Injection region BLMs – left IP2

Suggestion of changes – version 1

IP2 left currently installed ICs at MBs;
all for B2 - inside

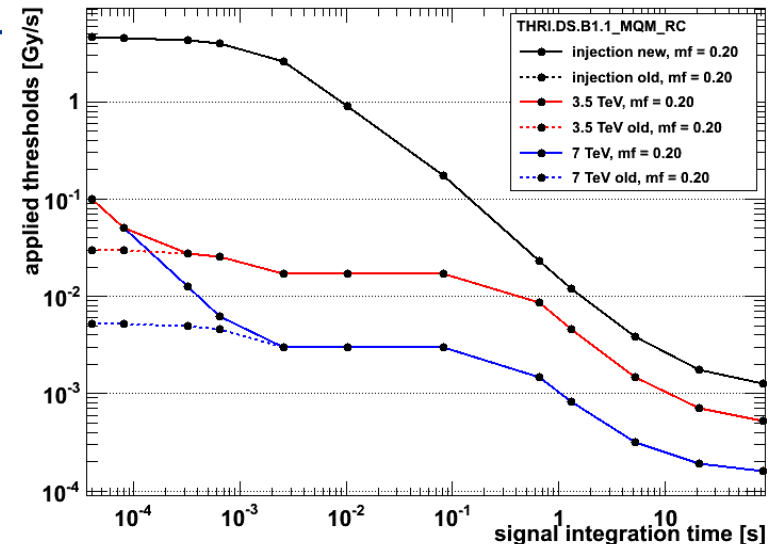
New locations

7 ICs

7 ICs

7 mobile?

6 ICs

IP2 left currently installed ICs at MBs; all for B2 - inside

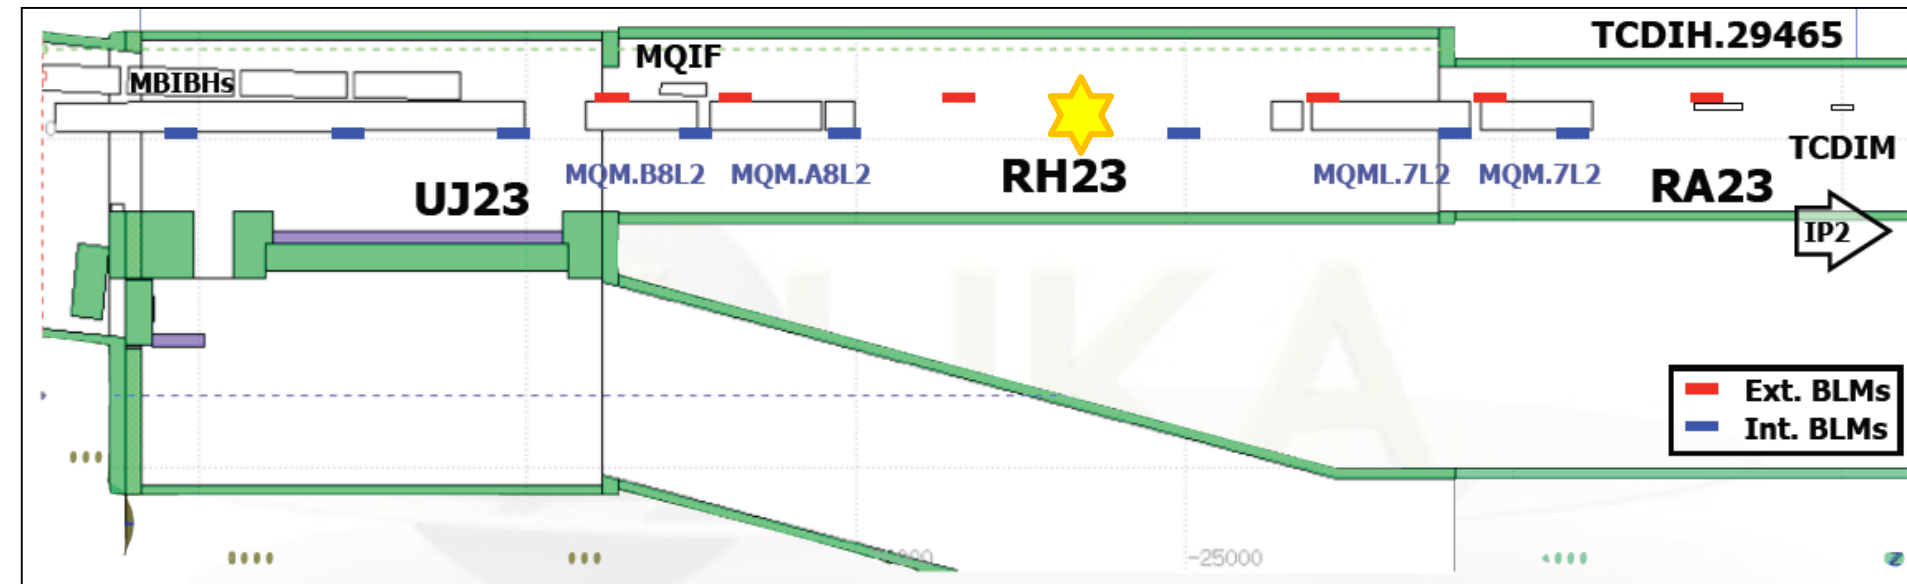
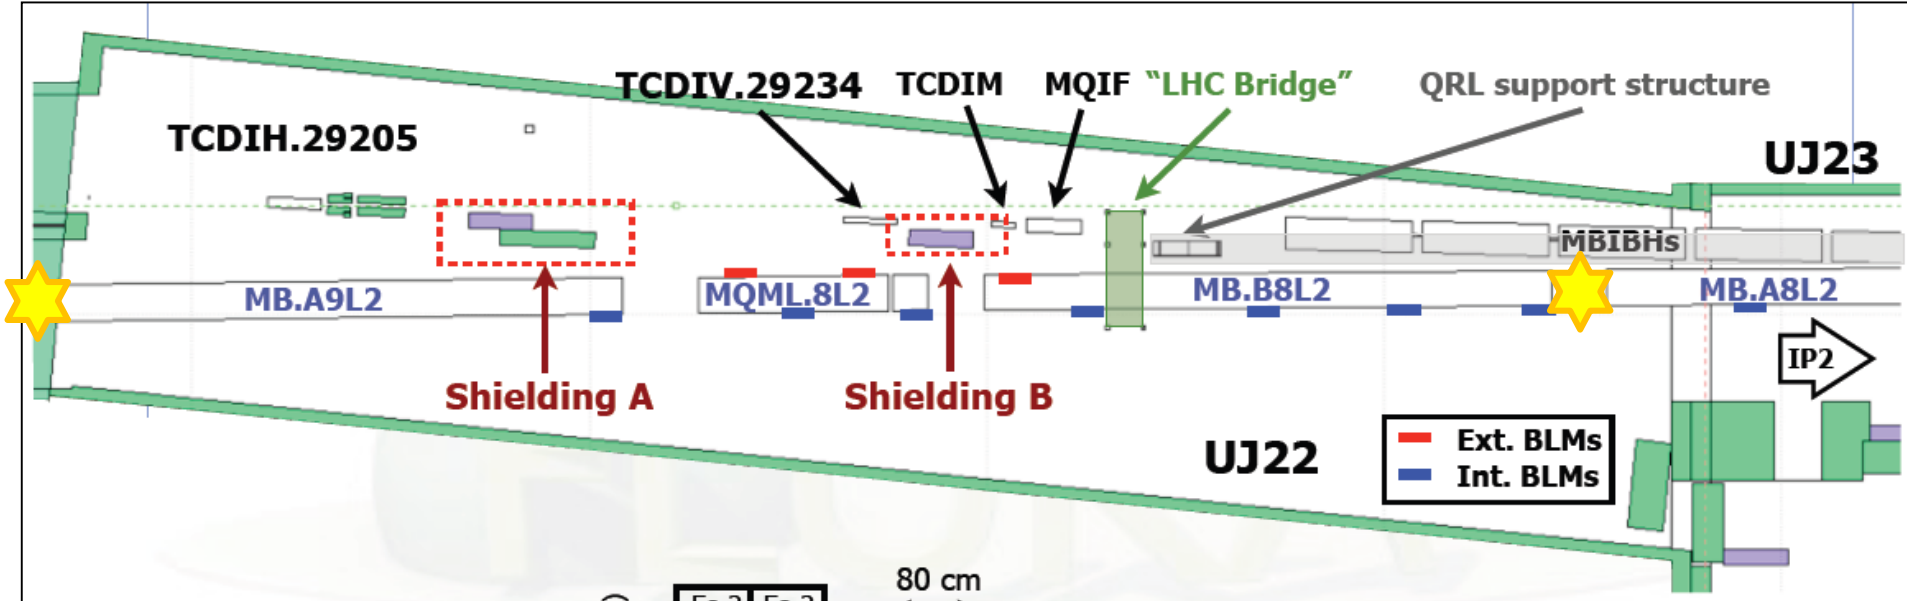
- Need to re-locate only one BLM per quadrupole
- Injection regions: propose to relocate the **outside** monitor (higher signal from injection line showers)
- Simulation of the signal of the showers from injection line losses on the new location do not exist – and are not planned
 - Rather strong variations longitudinally (see next slides)
 - Top position is not shielded by magnets. Still, for geometric reasons I'd expect a somewhat smaller signal than at the external position

7 ICs

7 ICs

7 mobile?

6 ICs
